Original Permit No. 100/100
Amendment No. 1

AMENDMENT TO APPLICATION FOR PERMIT

DECLARATION AND STATEMENT ACCOMPANYING APPLICATION BY JACOB LEVINSKY FOR A
LICENSED PERMIT TO COVER ALTERATIONS IN THE BUILDING AT 272-274 CONGRESS STREET,
CORNER OF INDIA STREET

LOCATION PLAN
FOR
ADDITION TO BUILDING
OF JACOB LEVINSKY
AT 272-274 CONGRESS ST.
CORNER OF INDIA ST.

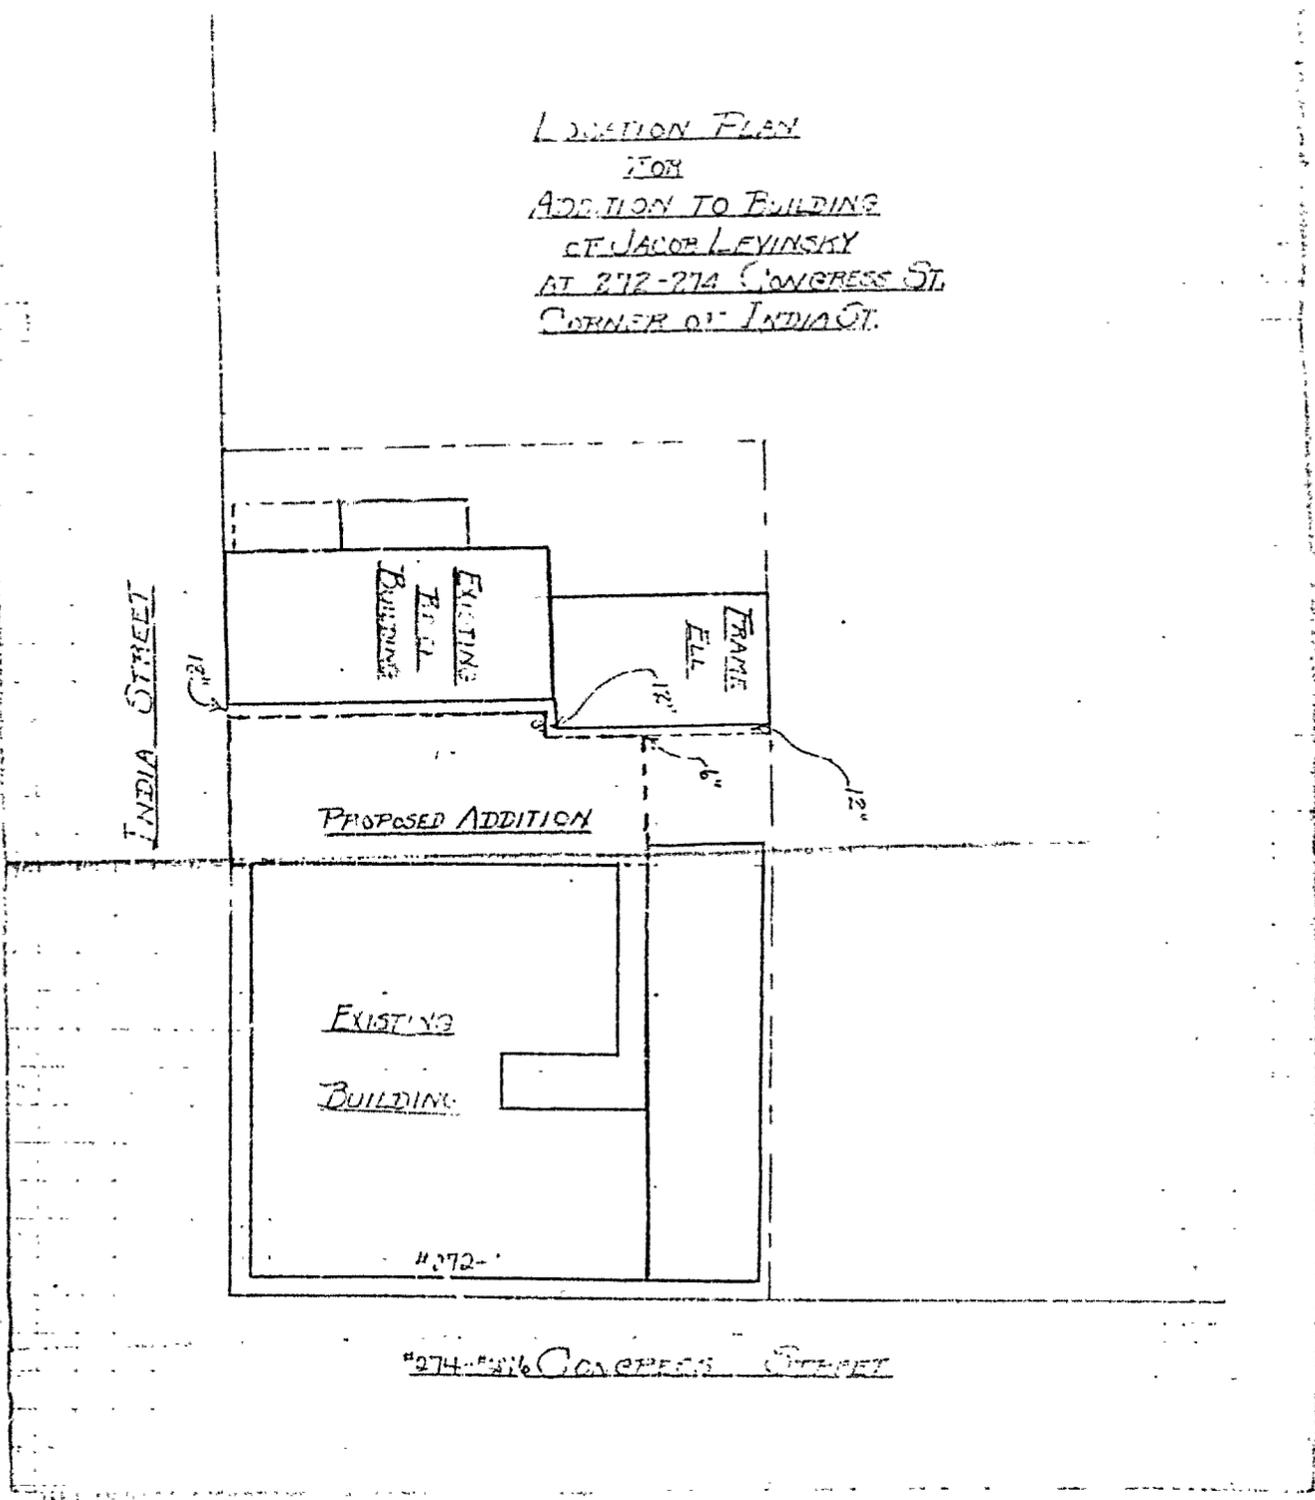
AJS- Messrs. Levinsky, and Butland failed to supply information as to the existing second floor framing which is to become a part of the new flat roof. They have agreed verbally to make it competent to take the roof load of 50 lbs. plus dead load.

The question of the side exit door is a mean one. Rhodes by mistake has shown the new door and platform at the cellar level. The code requires at least two exits "as far apart as possible". Tenant intends to use only two of the front entrance doors. Chief Sanborn for some reason has said he will accept the rear receiving door, even swinging in and locked with a key as sufficient. I am afraid my duty will not allow me to under the Building Code, so we will sit tight with their agreement to provide it, and see what happens.

I overlooked that they are to lower existing first floor when I examined plans, but Butland has agreed verbally to anchor every third floor joist like this:
